MY3 Monitoring Report

Owen Farms Mitigation Site
Transylvania County, NC

Re: MY3 Monitoring Report Comments
Owen Farms Stream and Wetland Mitigation Site
French Broad River Basin; CU# 06010105 – Transylvania County
DMS Project ID No. 100064
Contract No. 7532
SAW-2018-01165

Response to DMS Comments

Figures 8.1 – 8.5 Wetland Groundwater Gauge Data

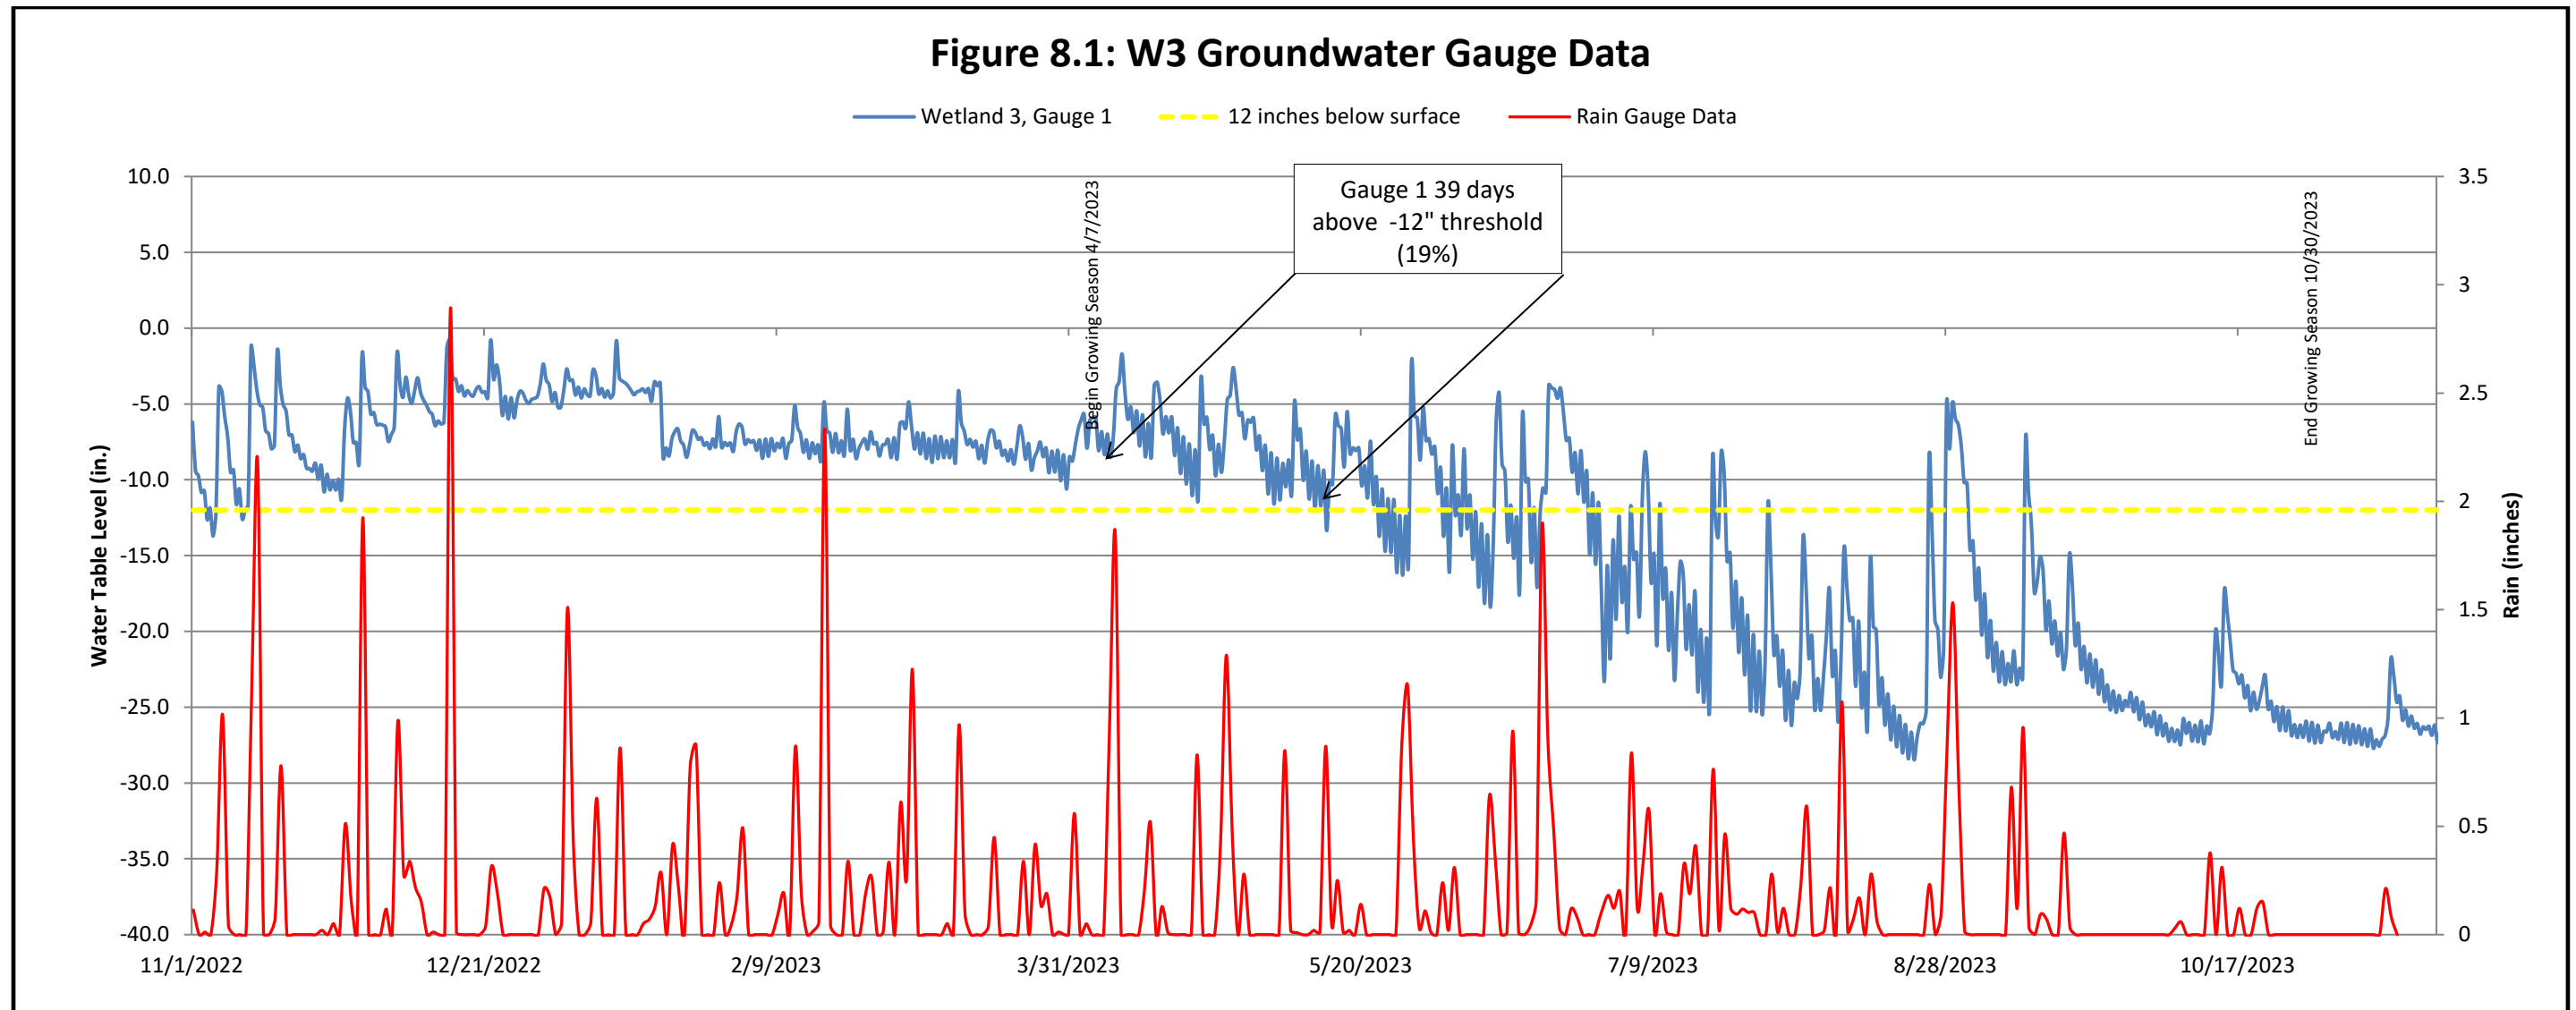
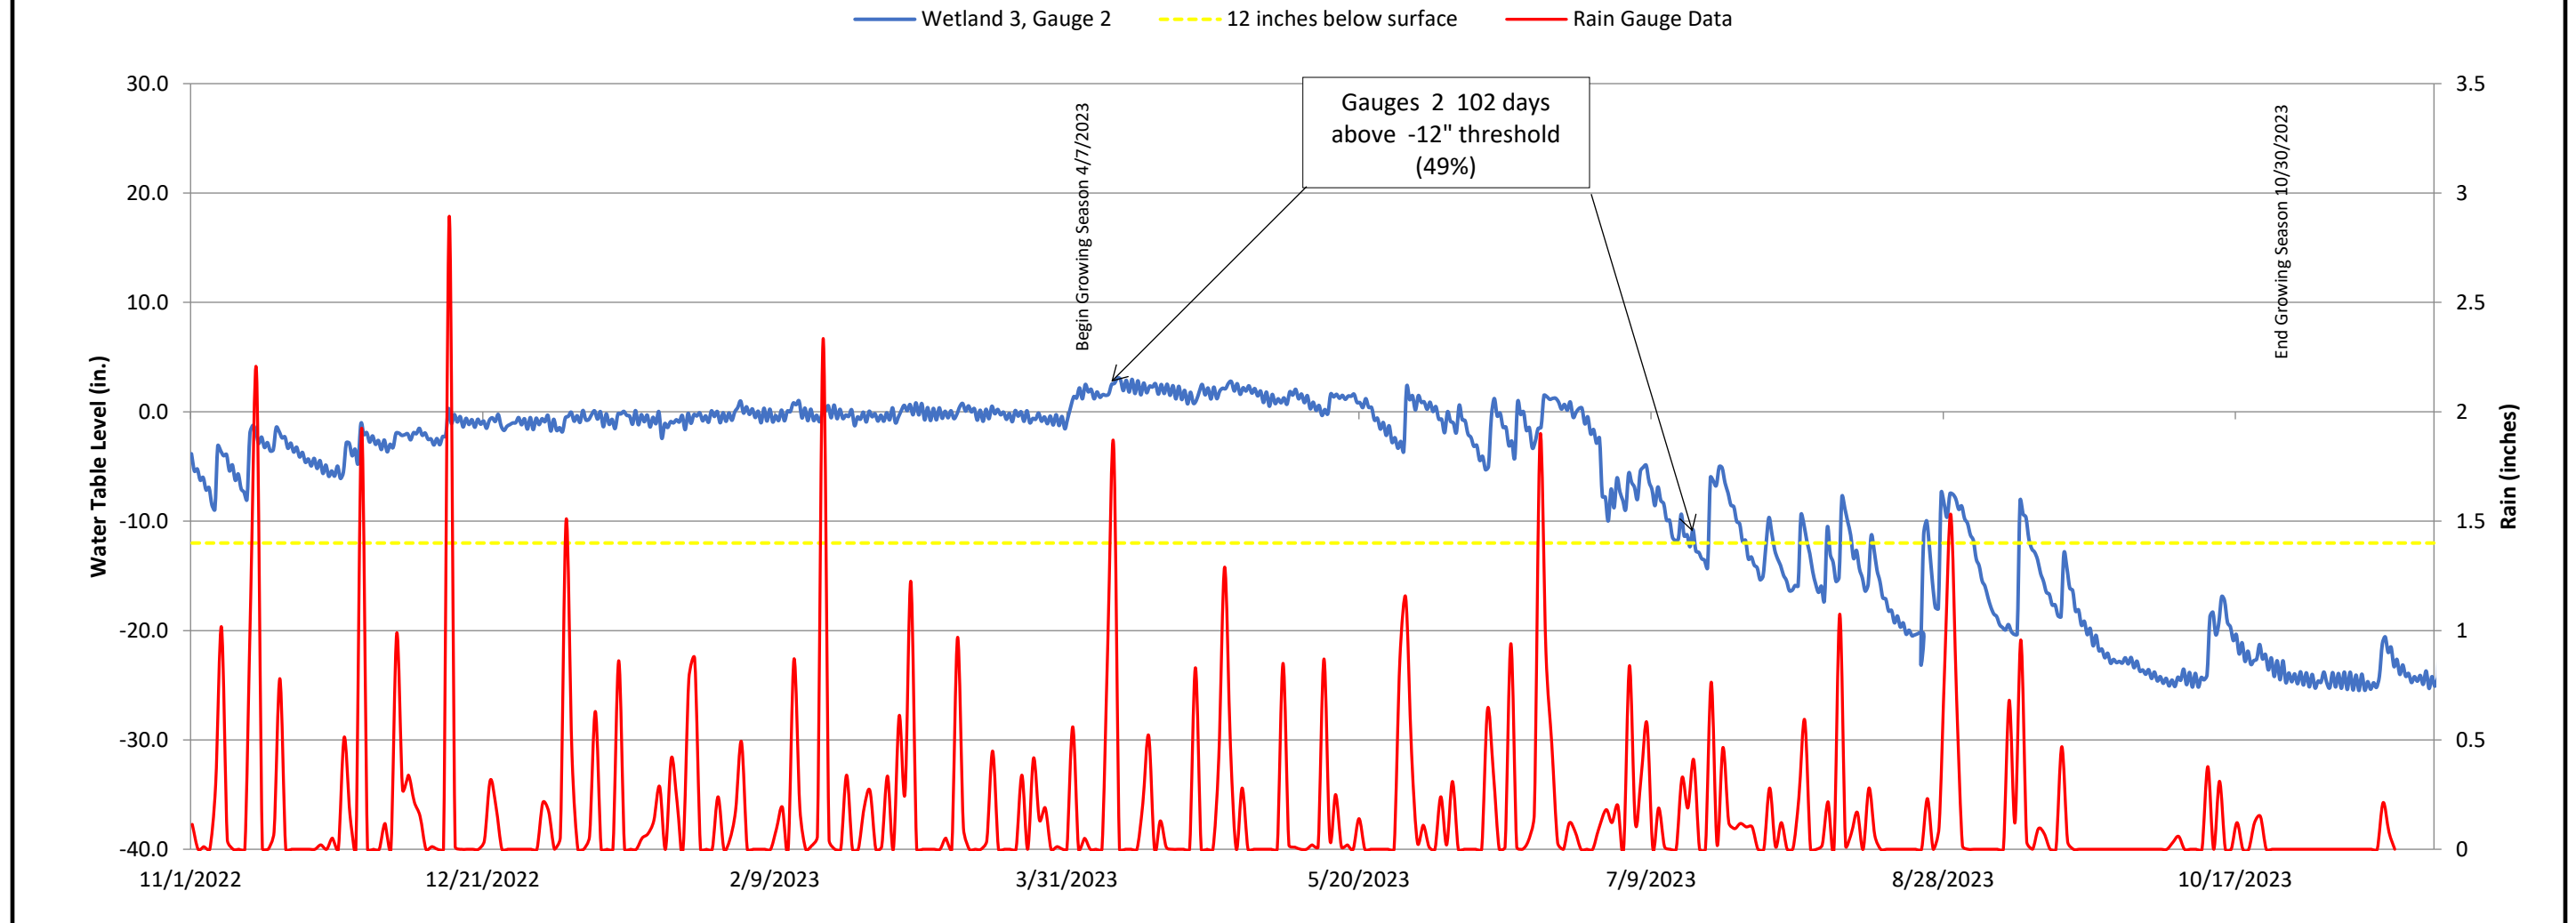
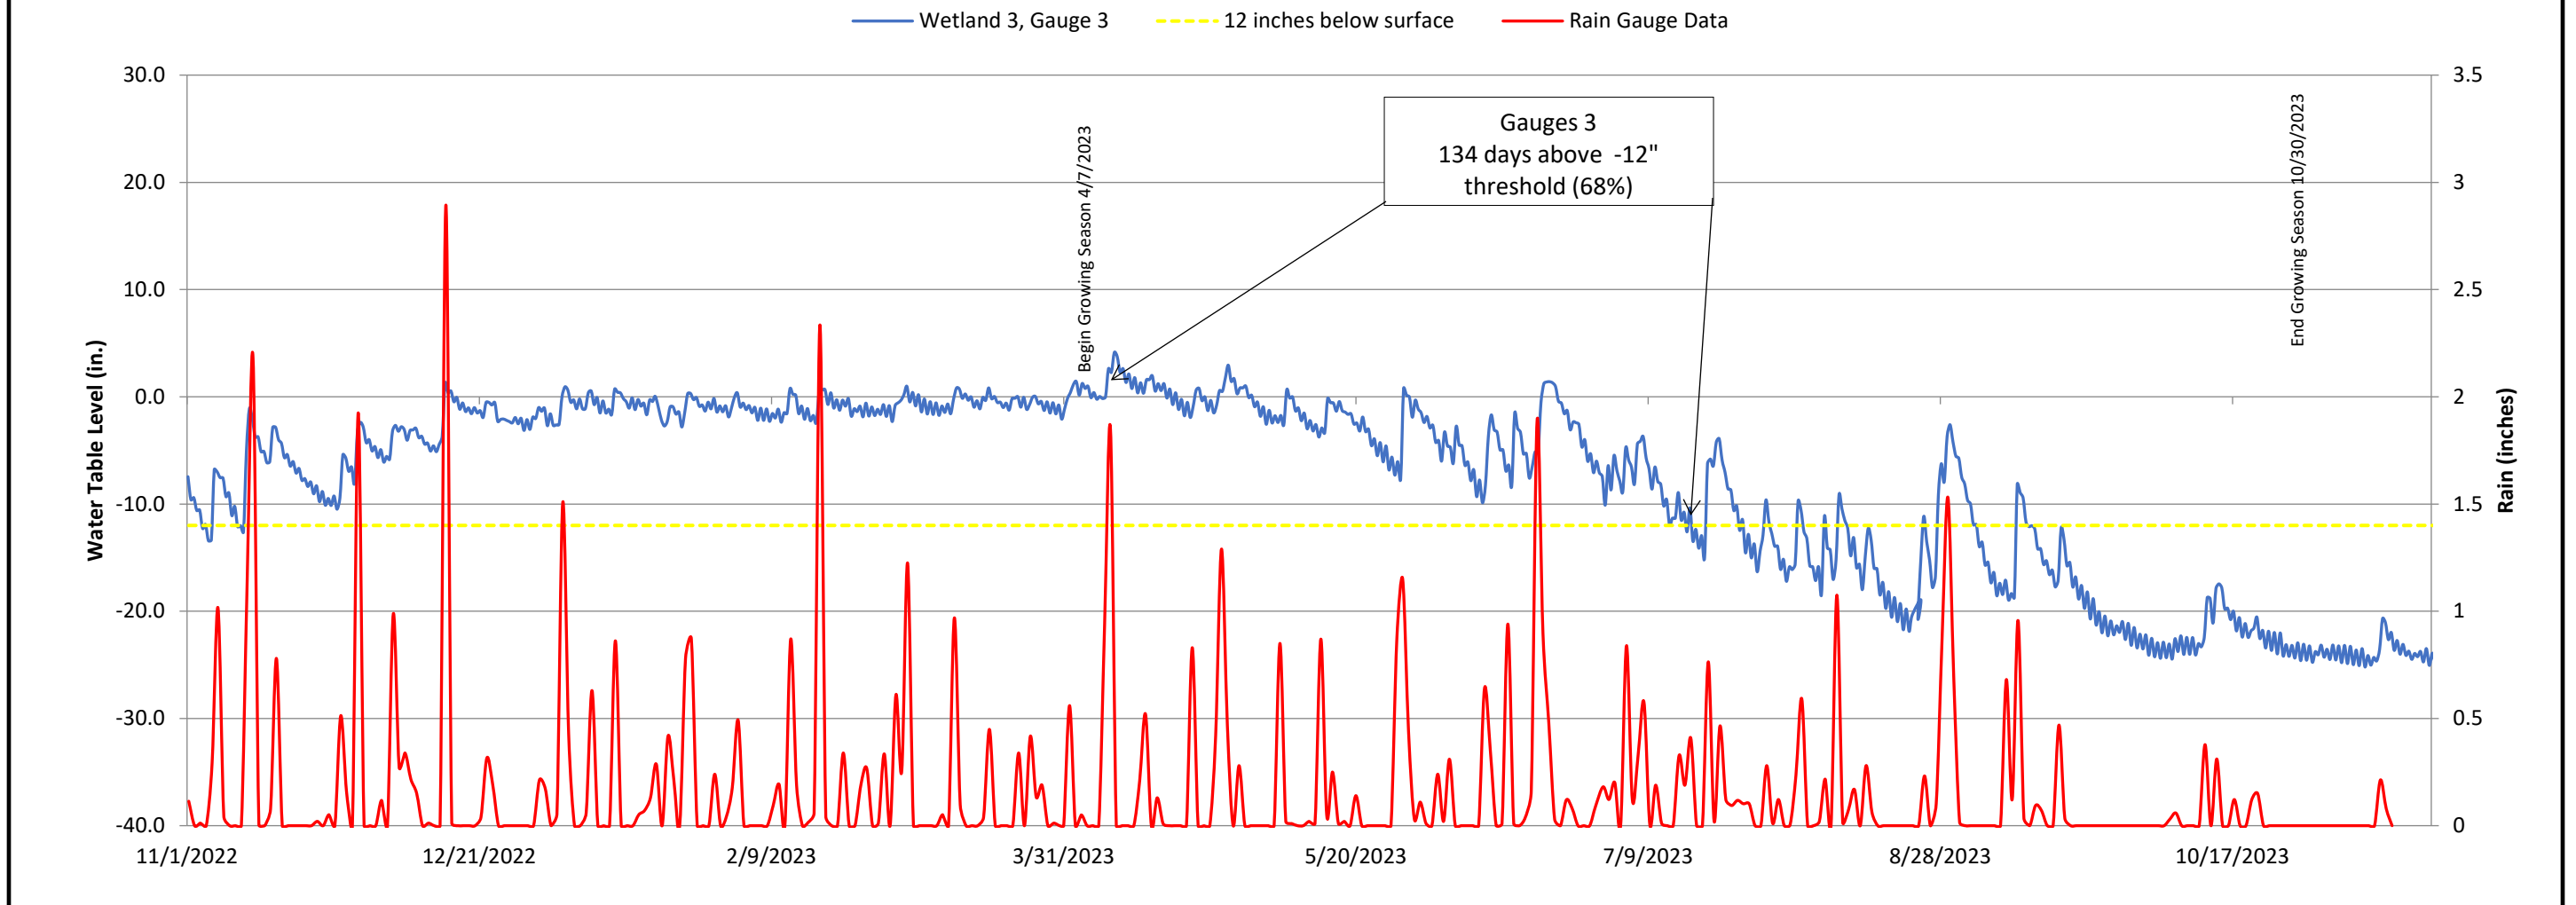
10: Figures 8.1 – 8.6 Groundwater gauge data graphs: Please review and confirm that the data reported is accurate and the graph callouts are correct. As an example, the Gauge 1 (Figure 8.1) callout shows occurrences of the groundwater line well below the “12 inches below surface” line. Please also be consistent with the graph colors utilized. Figure 8.6 has a green “Wetlands 5, Gauge 5 line”. Please review and update the report and graphs accordingly. *Graph data has been reviewed and updated for accuracy and callouts have been updated accordingly.*
